CLUBSWAN 36

Notice #04/2023

Keel Grid Limber / Drainage Holes

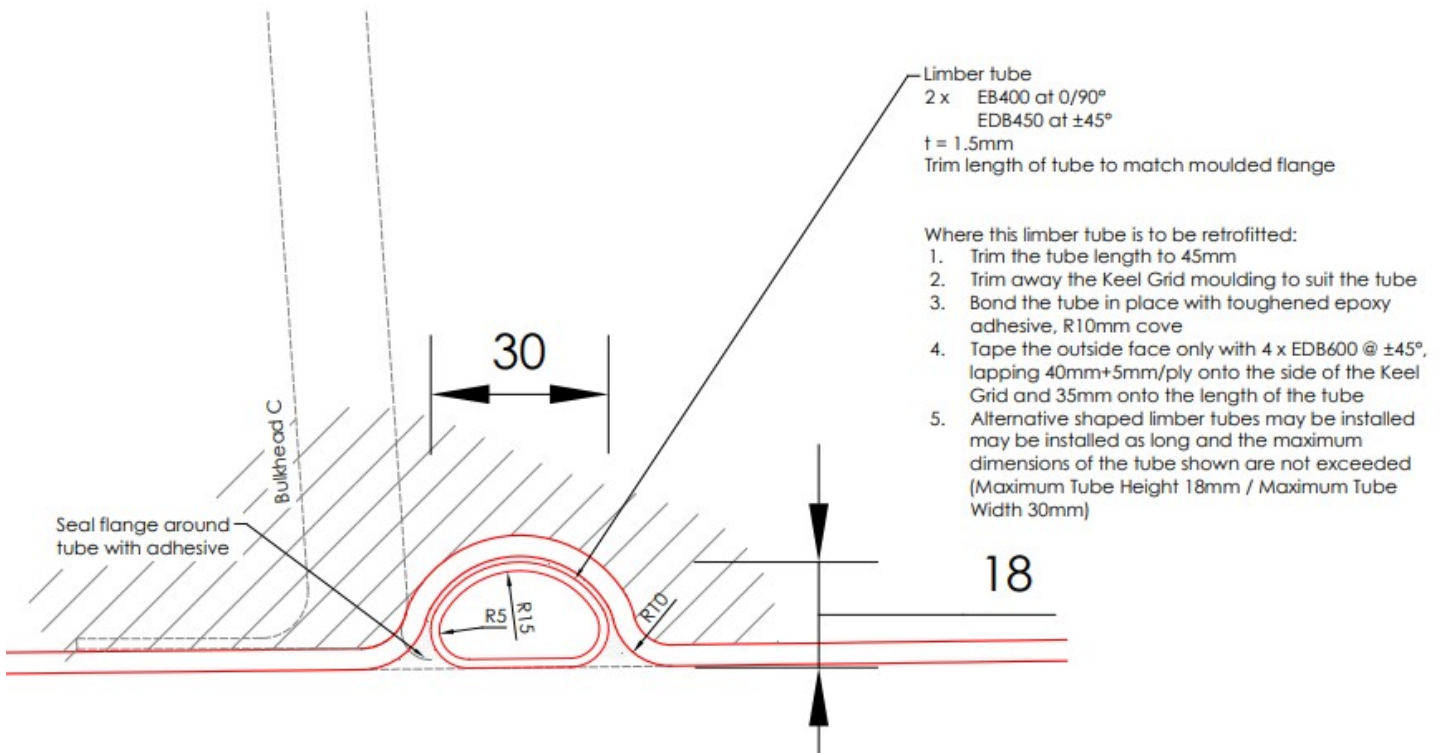
To allow more efficient drainage of any trapped water in the keel grid it is permitted for teams to enlarge the limber / drainage holes forward of the mast bulkhead. Detailed below is the required laminate specification and maximum permitted dimensions.

Removable bungs or stoppers may be added to these limber holes to limit water ingress during sailing.

The laminate specification must be in accordance with the drawing below:
